Current ENERGY STAR Single-Family New Homes Policy Record

How to Use This Document

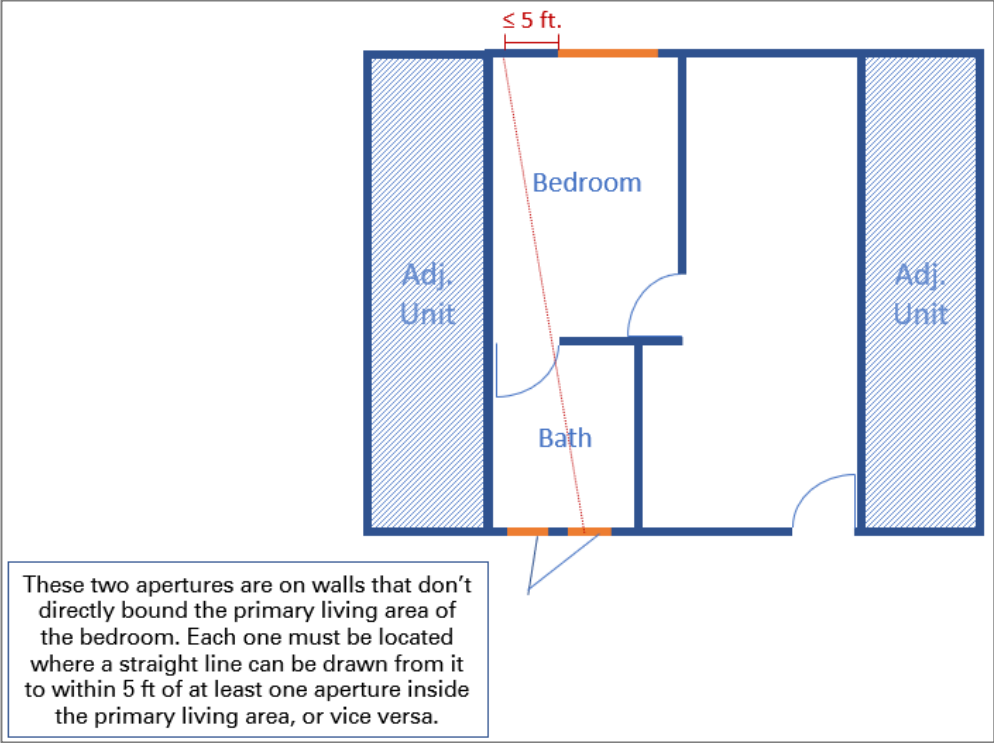
If apertures must be on walls that directly bound the primary living area, then there is no way to meet this Item unless the design incorporates wing walls, which stakeholders have indicated are not common practice.

Allowing apertures to be located on walls outside the primary living area would ease compliance while not necessarily compromising the original intent of the requirement, to promote effective natural ventilation.

Resolution: Clarifying the requirements for aperture location will promote consistent implementation of the program requirements, while adding a pragmatic allowance that does not alter the original intent of the requirements.

Apertures will be allowed to be located outside the primary living area if they meet two prerequisites that promote effective natural ventilation. Namely, the apertures outside the primary living area must be effectively aligned with at least one aperture inside the primary living area. More effective ventilation should be promoted by not allowing circuitous or obstructed routes between apertures.
